From: David White <davidw@benedict.com.au>
To: David.Mooney@planning.nsw.gov.au
Date: 11/11/2013 9:48 AM
Subject: Moorebank Recyclers 0157

Re: Major Project 0157 - Exhibition of Preferred Project Report

Moorebank Recyclers Pty Ltd | Moorebank Recyclig Facility Noise

Report J13116RP1 | Prepared for Moorebank Joint Venture | 11 November 2013

Table 4.1 Predicted noise levels (EMM and others) vs criteria

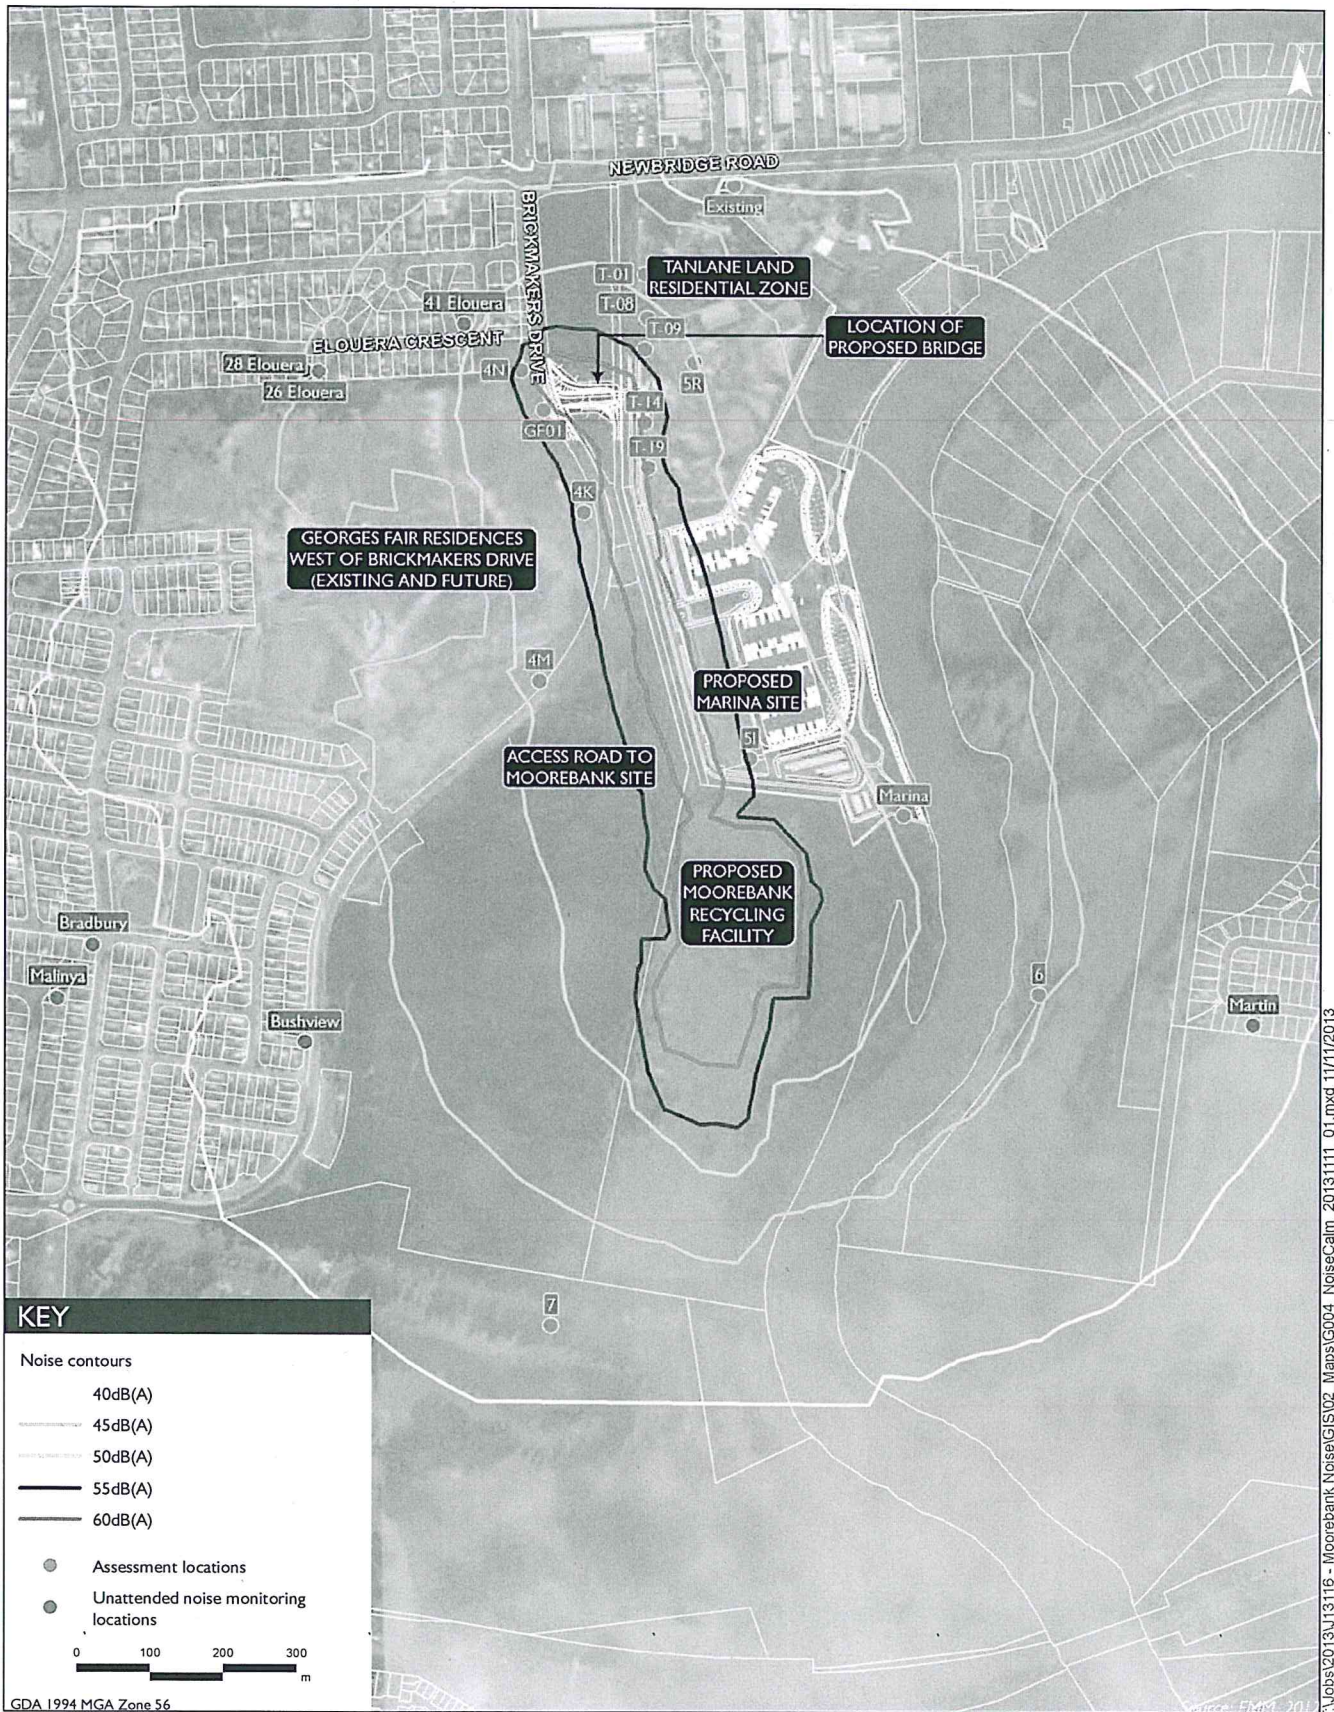
The results of our noise modelling is shown in Table 4.1 and depicted graphically in Figure 4.1. The results show:

- Noise levels are predicted to exceed criteria at proposed Georges Fair residences adjacent Brickmakers Drive by up to 9 dB (location GF_01). The barrier versus no barrier result is unchanged as this receiver as it is almost directly opposite the bridge crossing and hence the barrier does not provide any shielding to this property from the closest trucking operations on the ramps. Our results are higher than those presented by both Wilkinson Murray and Renzo Tonin, which cannot be explained;

- Noise levels are predicted to exceed criteria at existing Elouera Crescent residences;
- Noise levels are predicted to exceed criteria at future Tanlane residences by up to 9 dB (location T_14) with no access road barrier. This Tanlane location is potentially the closest future receiver to the access road and bridge crossing. The noise contours (Figure A in Appendix A) shows that the criteria (49 dB(A)) is predicted to be exceeded across approximately 50% of the Tanlane land, which is a significant impact. Discussions around the feasibility of a road barrier or tunnel is provided below. Our predictions are 6 dB higher than Renzo Tonin's barrier scenario.

- Noise levels are predicted to exceed criteria at existing Bradbury Street residences by 3 dB, without a barrier and by 2 dB with a barrier.
- Noise levels are predicted to exceed criteria at future passive recreation areas (foreshore area) of the proposed marina.

EMM has completed a review and assessment of the proposed Moorebank Recycling Facility and conclude that truck movements along the proposed site access road and bridge crossing ramps cannot be reasonably and feasibly mitigated to achieve noise criteria. Of most significance is the exceedance of criteria across approximately 50% of the residentially zoned Tanlane land.
